10/764,302

Office Action Summary

CHARTIER ET AL.

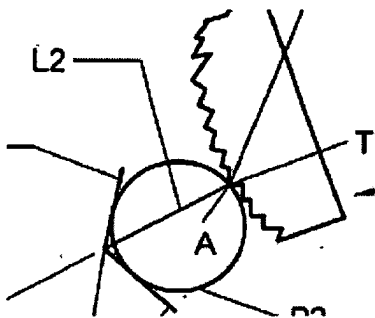
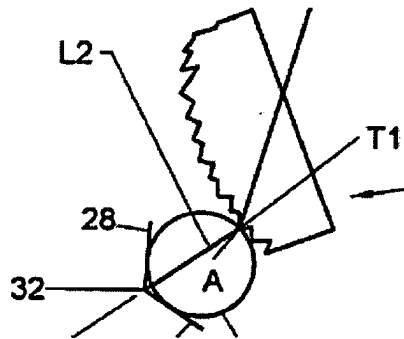
Attachment “A” is an enlargement of figure 1 of Gunnarson. The plurality of teeth are shown as lying along the fixed jaw “B”. The blue markings show at least three of the plurality of discrete teeth wherein each discrete tooth is for engaging one of a plurality of workpieces having different diameters. The remaining discrete teeth lie between teeth “1” and “2” and between teeth “2” and “3”. Teeth are located between adjacent ones of the discrete teeth (the teeth between the discrete teeth that do not engage a workpiece) since not all of the teeth engage a workpiece. Note that Gunnarson discloses nine workpieces and twenty teeth on the fixed jaw. Gunnarson discloses the camming angles as marked in red for at least three of the discrete teeth with corresponding workpieces.

The discrete teeth are shown in attachment "A" (previously sent to applicant in the parent application and attached to the preliminary amendment filed January 6, 2004 in the instant application), wherein there is single tooth contact (by either tooth 1, tooth 2, or tooth 3) of the discrete teeth provided for contact with a different one of a plurality of cylindrical workpieces and just one (tooth 1, tooth 2, or tooth 3) of said plurality of discrete teeth provided on said fixed jaw for the workpiece of a given diameter. The remaining teeth in Gunnarson define the teeth between adjacent ones of the discrete teeth. This is similar to applicant's invention wherein teeth "50" also engage the workpiece.

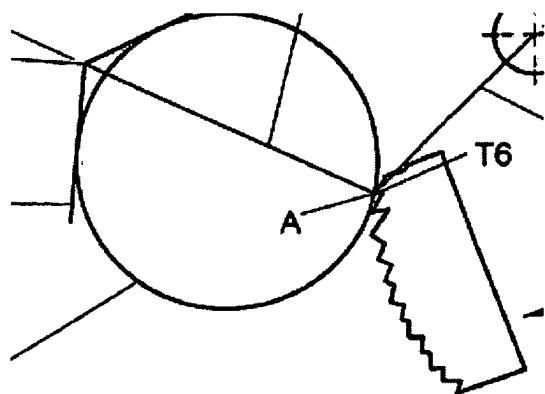
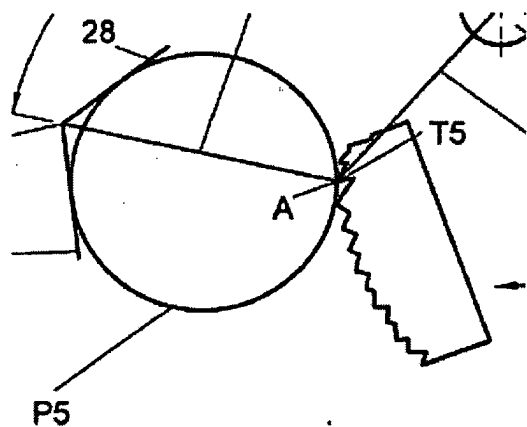
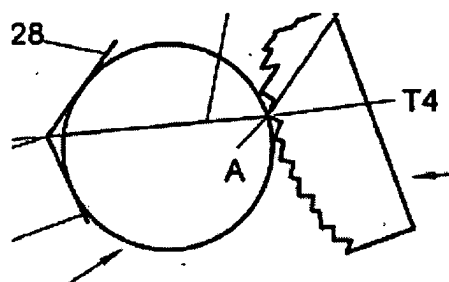
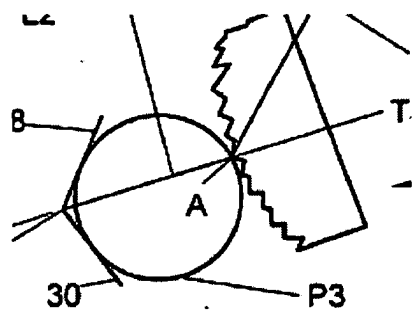
Applicant appears to be arguing that Gunnarson discloses plural teeth engaging the workpiece and not a single tooth. It is noted that applicant's invention also discloses

plural teeth that engage the workpiece, wherein one of the teeth includes a discrete tooth. Note figures 6A-F and figure 7, below, of the instant application wherein a discrete tooth and an additional tooth engages the workpiece just as the teeth of Gunnarson do. Page 5, lines 13-17 of the instant application also defines discrete teeth and additional teeth to promote gripping.

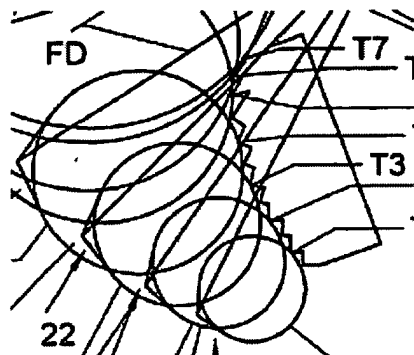
15 T7 also accommodates gripping a 1-1/2 inch pipe fitting. While it is not necessary to provide any additional teeth on jaw member 18 other than the discrete teeth T1-T7, it is preferred to provide additional teeth 50 between adjacent ones of the discrete teeth T1-T5 to promote the gripping capability of the wrench with regard to pipe fittings, rod and other objects and workpieces in addition to the series of pipes. While reference herein is with regard to the foregoing nominal pipe sizes, it

It is noted that the specification of Gunnarson need not define a plurality of discrete teeth since the drawings clearly disclose such teeth as set forth, above. Teachings may be found in any portion of the disclosure including the specification, the abstract, the drawings, and the claims.
